Zoning Docket from January 13, 2020 Public Hearing

RE: CZ-2020-10

RE: **FRD Re-Submittal Package**
Pelham Road/Boiling Springs Road FRD
County Application: CZ-20-10
Along Pelham Road at Boiling Springs Road
Greenville County, South Carolina
GEC Project No. 2019064-P

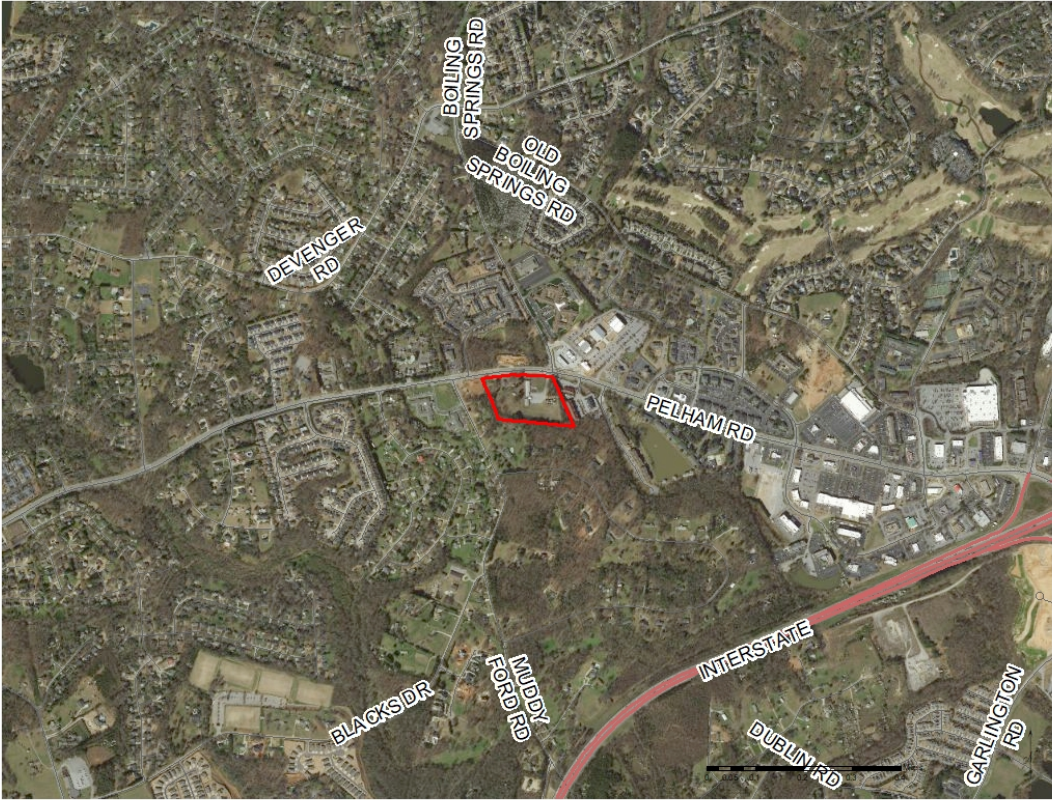
The applicant is proposing to construct 5 multifamily apartment buildings consisting of 265 one, two, and three bedroom dwelling units and an additional 12 live/work spaces. A live/work space is where a resident can combine their workspace with their living quarters. The work portion of these units will range from approximately 868 sq. ft. to 1,615 sq. ft. The work spaces will be used for small office spaces or small-scale commercial uses and are primarily geared towards entrepreneurs, small businesses and professionals. Some examples include, but are not limited to, an office for professional services, photographer, one-on-one instructor, baker, coffee shop, clothing boutique and similar type uses. Per the Statement of Intent, these units will not allow vehicle repair or maintenance; adult businesses; massage parlors; large commercial restaurants utilizing a commercial kitchen; or uses that create excessive noise, dust, heat, smoke and odors that are considered a nuisance or are unsafe for other residents or employees. The overall development will consist of internal access drives with 396 parking spaces, a courtyard, and a swimming pool for the residents. The proposed development will provide a trash compactor that will be screened from view by an opaque building material (likely brick) which will complement the building materials within the development. There will also be a

All buildings will be 4 stories in height with three of the five main buildings (buildings 1, 2, and 4) having a partial basement level. These three buildings will be a maximum of 60 ft. in height and the other two buildings will be a maximum of 54 ft. in height. The work space units will only be located in the ground level units of buildings 1 and 2.

There will be two points of ingress/egress into the site, both off of Pelham Road. One will be provided at an existing signalized intersection, and one will be to the west, each meeting all requirements per SCDOT. The site will consist of 396 total parking spaces for both the apartments and the live/work units. The intent is for the parking spaces for the live/work units to be used during the daytime hours and then becoming free for the returning residents to have adequate parking spaces in the evenings. There are additional parking spaces provided to allow for those work spaces that may have customers that come in the evenings and on the weekends. The parking spaces will all be 9 ft. x. 18 ft. whether back to back or adjacent to a curb or sidewalk. There will be an internal sidewalk throughout the site connecting
